## Product Change Notice

Issue Date: 18 June 2021

Change of LED marking orientation in carrier tape

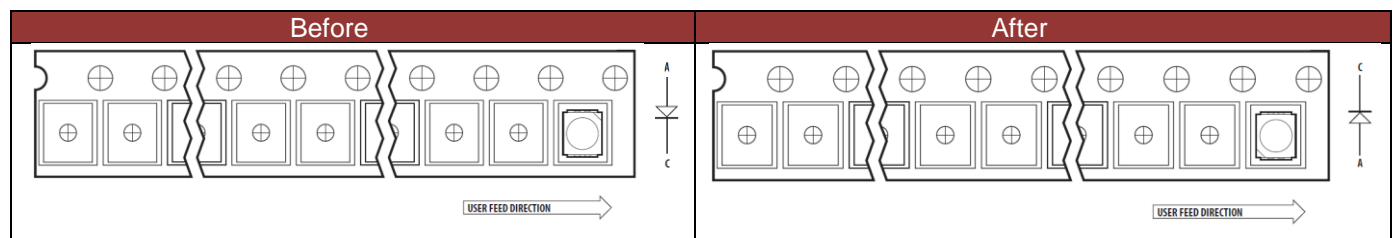
Devices are reeled so that cathode is oriented properly with the direction of feed and round sprocket holes.

There will be no change on fit, form, function, quality and reliability of final product except the LED orientation in carrier tape as illustrated below
